# Request For Clarification: Headform Test Procedure

48<sup>th</sup> Session of UNECE GRSP,  
Geneva, 07 – 10 Dec. 2010

Drawing: gtr No. 9, part B, figure 11

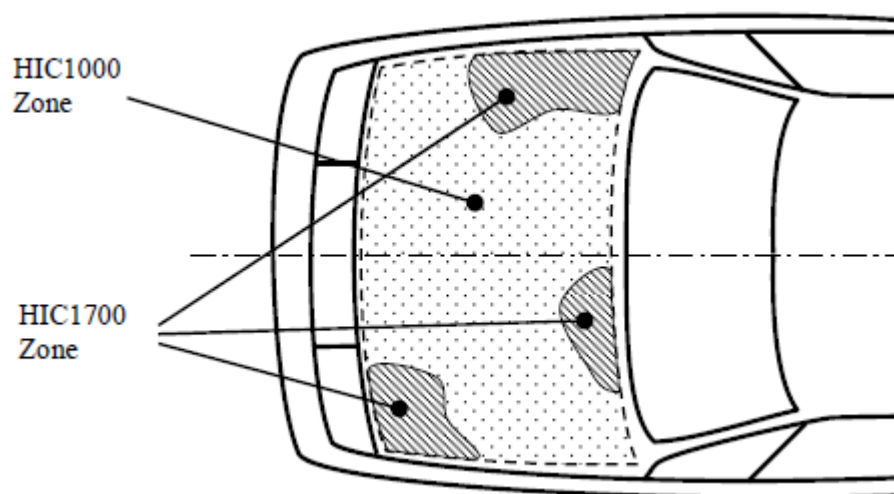
- Impact points are selected by Technical Service identifying points of possible risk (underlying structures, engine components, hinges, latches etc.)
- Selected impact points must be within the test area

Drawing: gtr No. 9, part B, figure 6

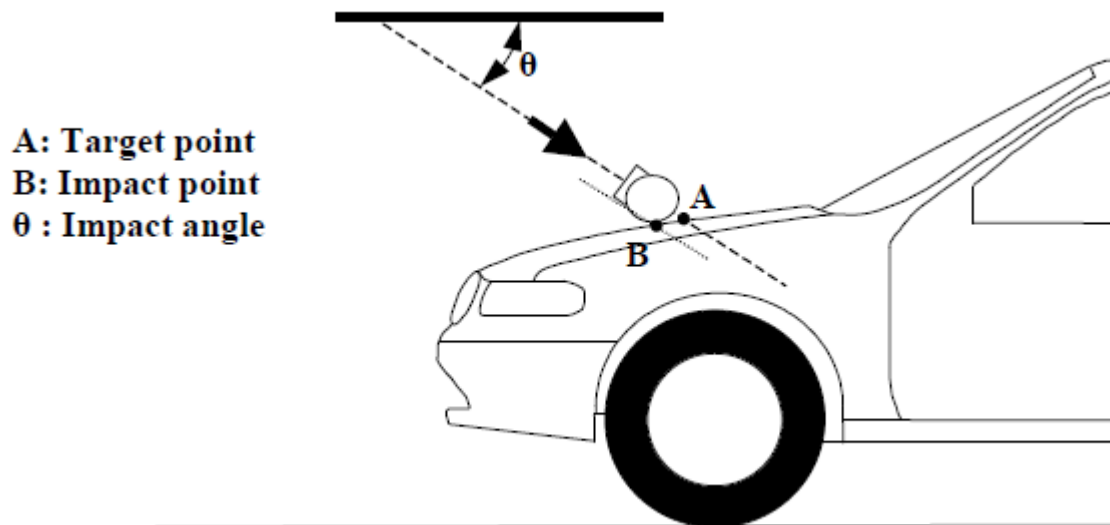
- Target points are chosen rearward of the selected impact point, considering the curvature of the headform impactor
- Target points may be outside of the test area

Example: Selected impact point vs. point of first contact

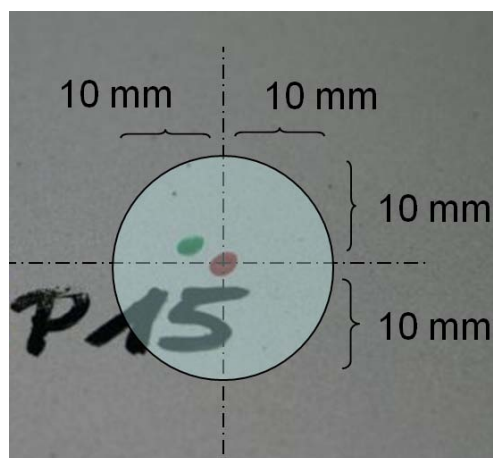
- Selected impact point and target point are in the same vertical longitudinal plane (see figure at the page before)
- Point of first contact has to be within 10 mm tolerance to the selected impact point
- This tolerance is assessing the accuracy of conducting the test

Example for a “jumping” bonnet surface in an x-plane (looked at the vehicle surface from the front)

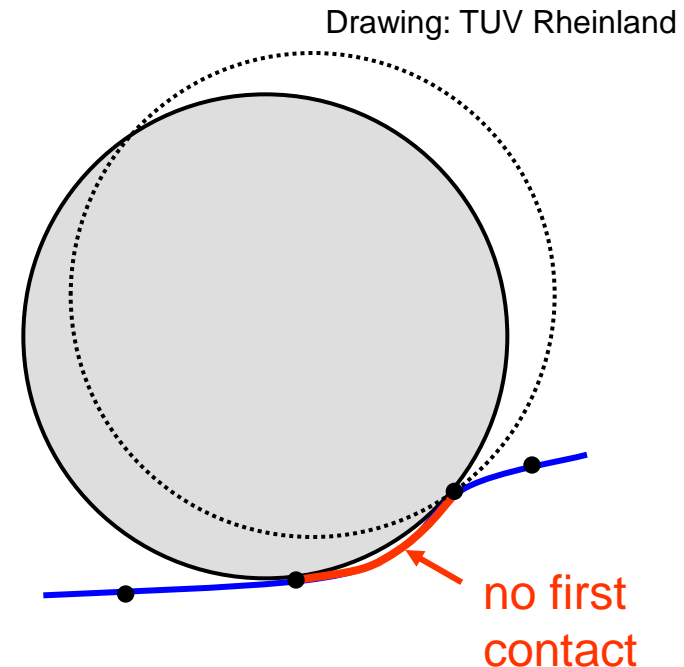
- However, the point of first contact can only be within this distance when the surrounding area in the lateral plane is nearly flat
- In case of lateral “jumps” in an x-plane (transverse vertical plane) the point of first contact may differ more than 10 mm
- Also, it can be physically impossible to hit the selected impact point or more than one points of first contact may occur
